Type Coffee Vending Machine	Model 9100 IN - 9200 CV	N° T.I. 03 - 2020
Serial Number 00721964	Subject INSTANT BOILER ASSEMBLY MODIFICATIONS	ISSUED FOR (X) Action Information <input checked="" type="checkbox"/>

MODIFICATIONS:

Modification 1

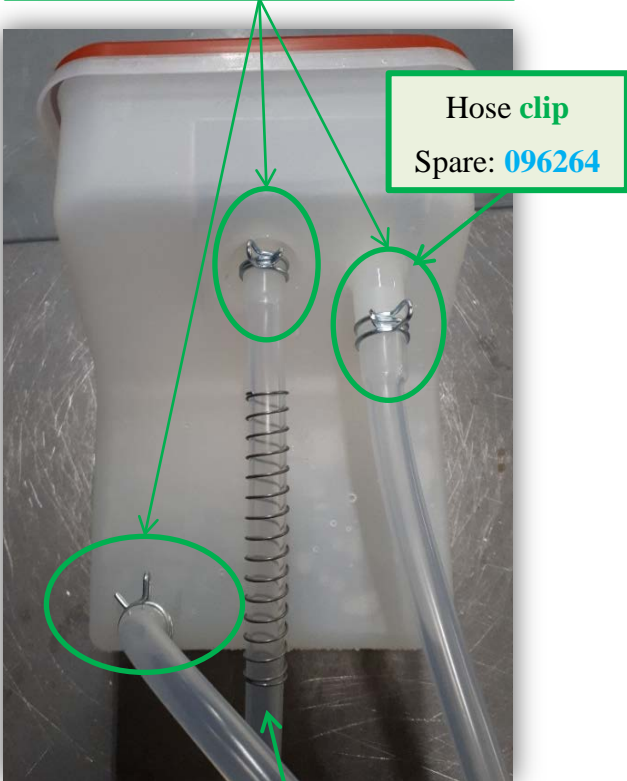
To avoid any boiler assembly hose from detaching and causing a water spill

- Three hose clips** have been added on the hoses coming out from the instant boiler
- The pre-modification brown silicone hose**, connecting the instant boiler to the pump, has been replaced by a transparent silicone hose, plus a fitting and a shorter brown silicone hose.

New solution
boiler body + 3 hoses + **3 hose clips**

Pre-modification solution
boiler body + 3 hoses

New solution
Instant boiler assembly

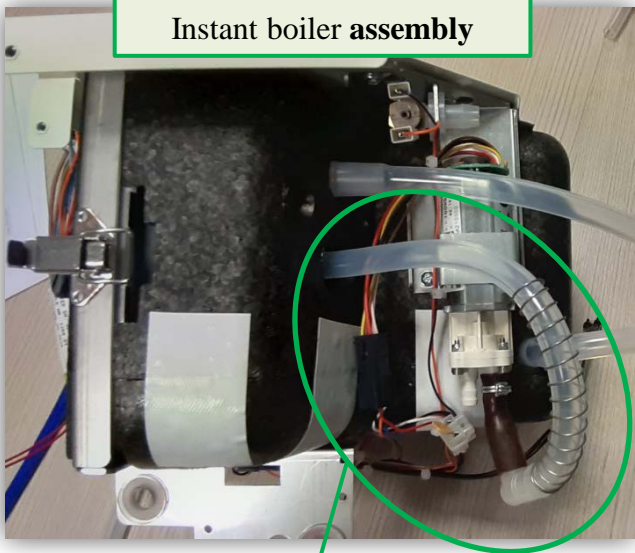
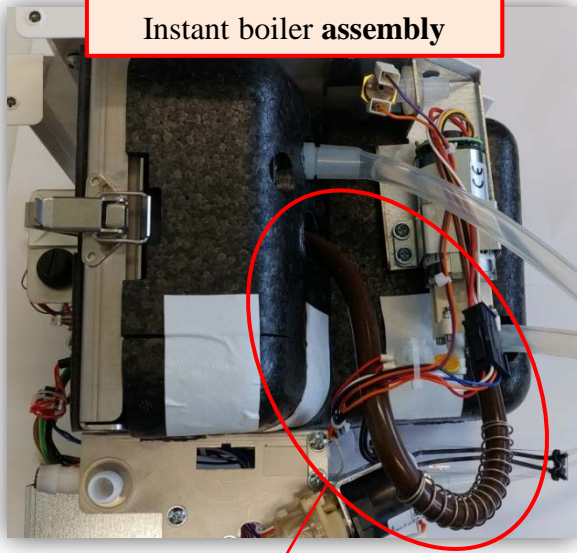
Pre-modification solution
Instant boiler assembly

The instant boiler assembly spare code is not changed: **260784**

For machines previous to above S/N it si possible to use the **new** instant boiler assembly

Modification 2

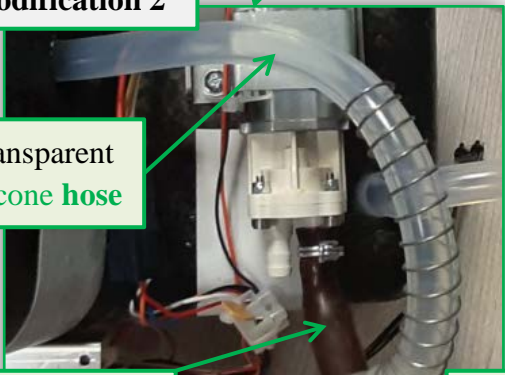
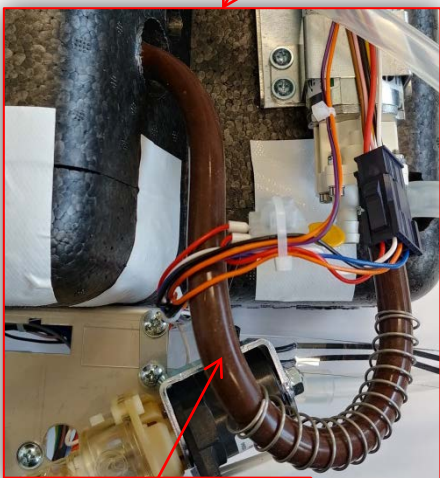
Transparent silicone hose
replacing the **brown one**

Transparent silicone hose

Shorter brown silicone hose (40 mm)
Spare: **097685**

PP elbow fitting
Spare: **39758800**

Pre-modification brown silicone hose

Length: **260 mm**
Spare: **255541**
